Access Compliance Report

Public Rights-of-Way

(Curb Ramps)

Intersection ID: 10024872	Main Street: DEWITT_LN	Cross Street: N/A	Location: SE
ADA ID: B3682235270B	Ramp Type: PerpDiag	Initial Pass/Fail: Fail	Overall Compliance: No
Severity Score: 25			
Codes/Mitigation Info/Possible Solution		Field Measurements/Component Compliance

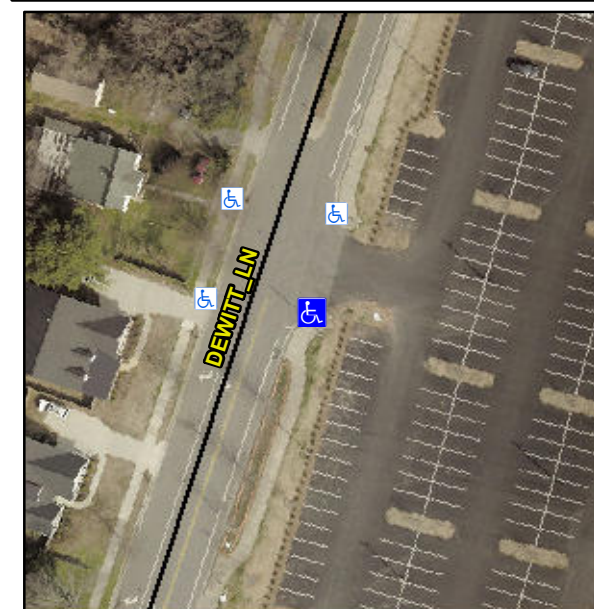
Not Found, R304.5.3

Compliance	Description	Data	Compliance	Description	Data
N/A	Ramp Length (in)	94.0	Yes	Ramp Slope (%)	7.2
Yes	Ramp Width (in)	48.0	No	Ramp XSlope (%)	9.6
N/A	Flare Type LT	N/A	N/A	Flare Type RT	N/A
N/A	Flare Slope LT (%)	N/A	N/A	Flare Slope RT (%)	N/A
N/A	Flare Traversable LT?	N/A	N/A	Flare Traversable RT?	N/A
N/A	Landing Length (in)	N/A	N/A	DWS Provided?	N/A
N/A	Landing Width (in)	N/A	N/A	DWS Contrast?	N/A
N/A	Landing Slope (%)	N/A	N/A	DWS Length (in)	N/A
N/A	Landing X Slope (%)	N/A	N/A	DWS Full Width?	N/A
N/A	Landing Curb? (Y/N)	N/A	N/A	DWS Offset (in)	N/A
N/A	Shared Landing?	N/A			
N/A	Gutter Ponding?	N/A	N/A	Gutter Slope (%)	N/A
N/A	Gutter Lip Ht (in)	N/A	N/A	Gutter X Slope (%)	N/A
N/A	Painted X Walk1?	No	N/A	Painted X Walk2?	No
	X Walk 1 Direction	To NE		X Walk 2 Direction	To NW
N/A	X Walk 1 Width (in)	N/A	N/A	X Walk 2 Width (in)	N/A
	X Walk 1 Slope (%)	0.9		X Walk 2 Slope (%)	6.6
	X Walk 1 X Slope (%)	6.9		X Walk 2 X Slope (%)	1.0

Remove & Replace Curb Ramp With Two New Directional Ramps or Equivalent.
